**RE: Tweed Shire Council Submission Cudgen Lakes Sand Quarry
MP05_0103B MOD 2**

I refer to your e-mail of 17 January 2018 in which you seek comment on the Cudgen Lakes Sand Quarry MP05_0135B MOD 2 (Council Reference DA08/1266).

Figure 11.2 Cudgen Village Indicative Structure Plan

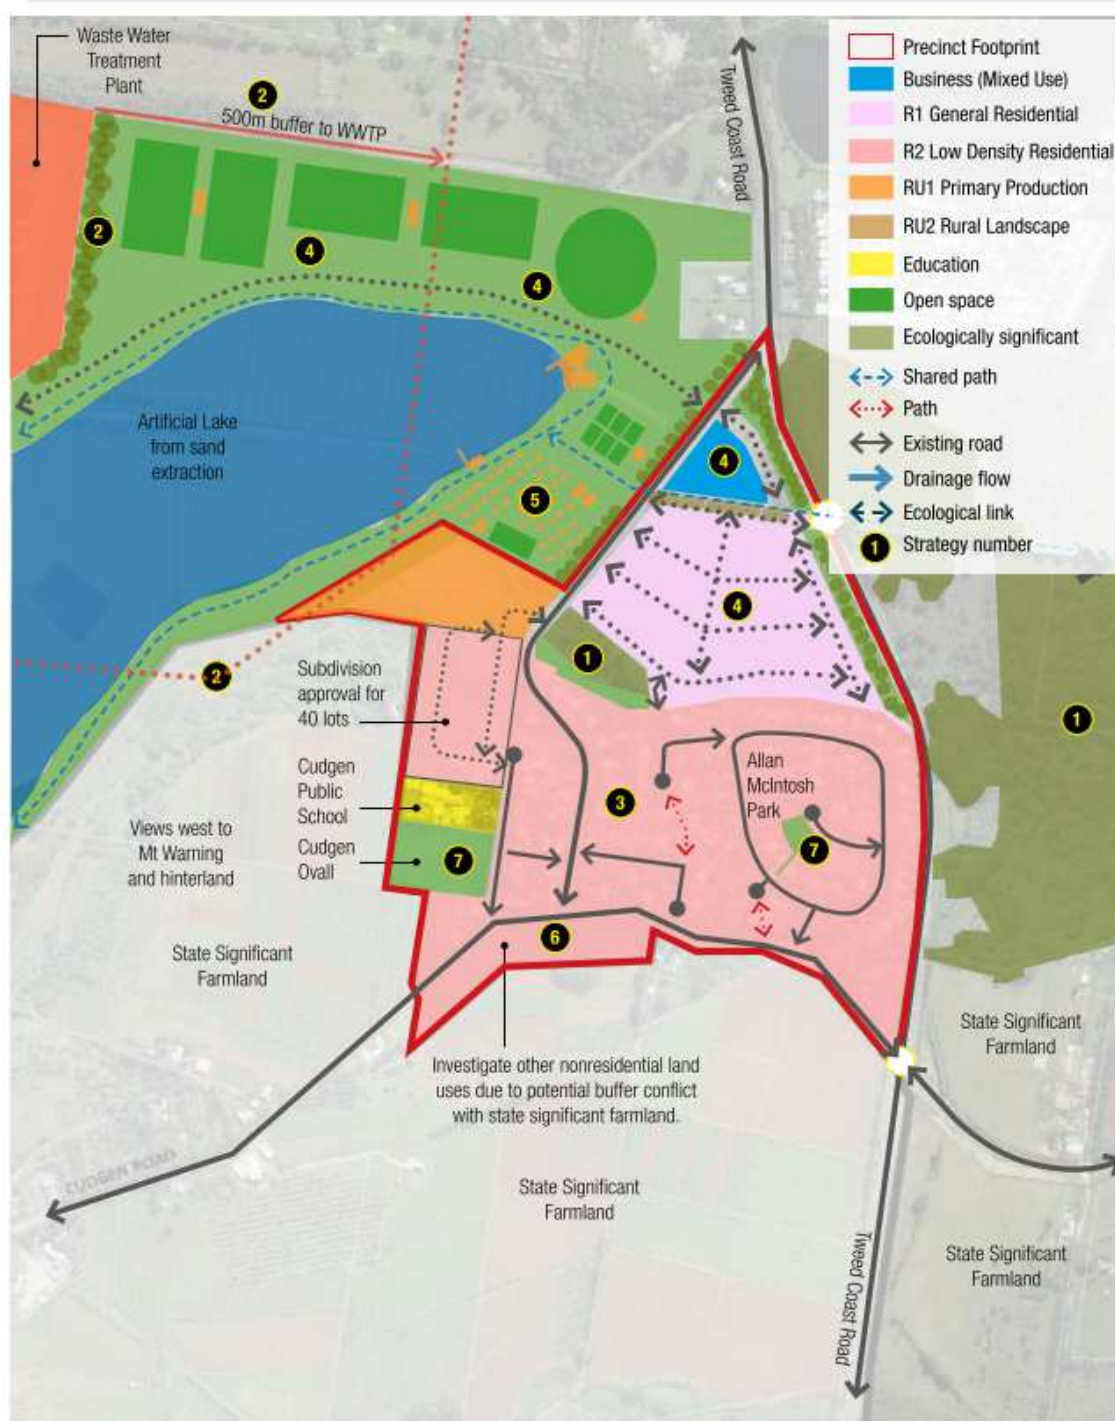
A 9.5ha section of land was explored as a possible future structured spaces area within the new business and knowledge precinct (north/east of the subject site). This plan has not been endorsed or publically exhibited and requires liaison with the land holder to lock in any future allocation of sports fields.

Council GIS showing the assets to the north of the lot within the road easement.

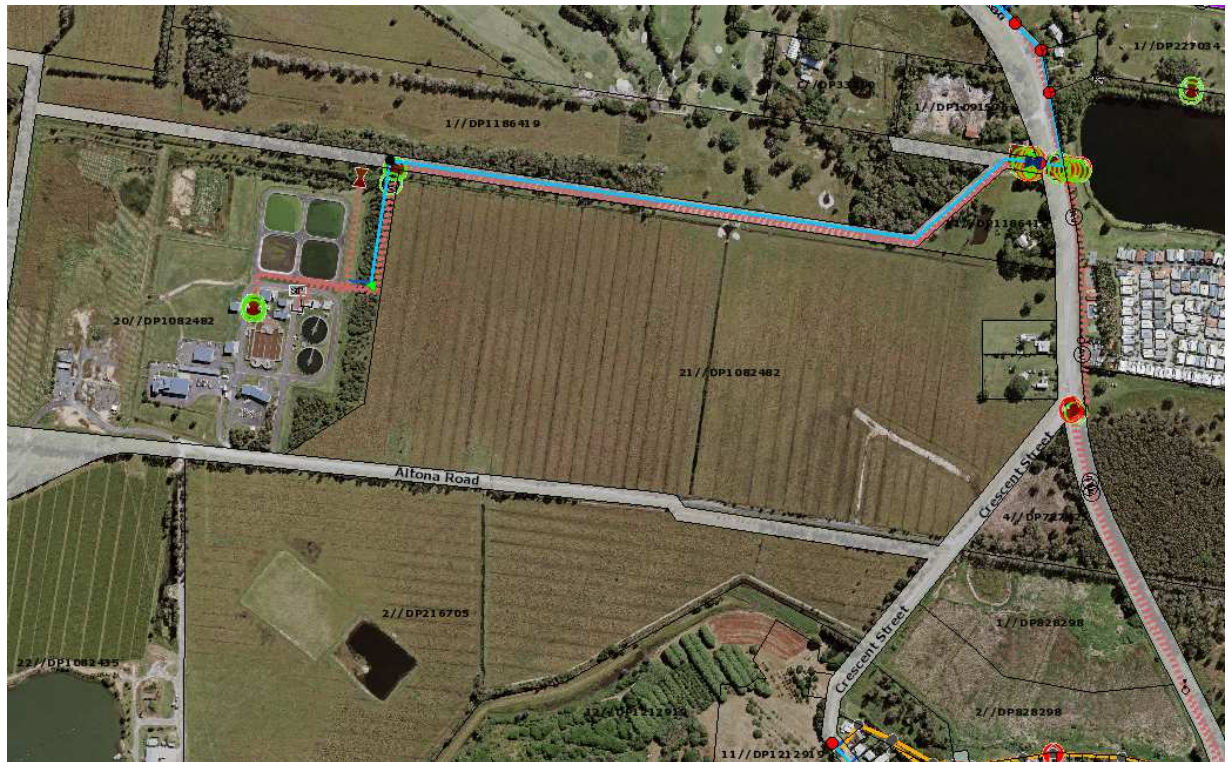
Therefore any approval issued by the Department that requires a different road alignment to that approved under DA05/1450 may necessitate the applicant lodging a S96 Modification to DA05/1450 with an amended associated Construction Certificate (fees per hour). **The Department could consider requesting the applicant lodge a concurrent DA/S96 for the amended road alignment to the Mod currently being determined by the Department to ensure all Government and Council consents continue to align.**
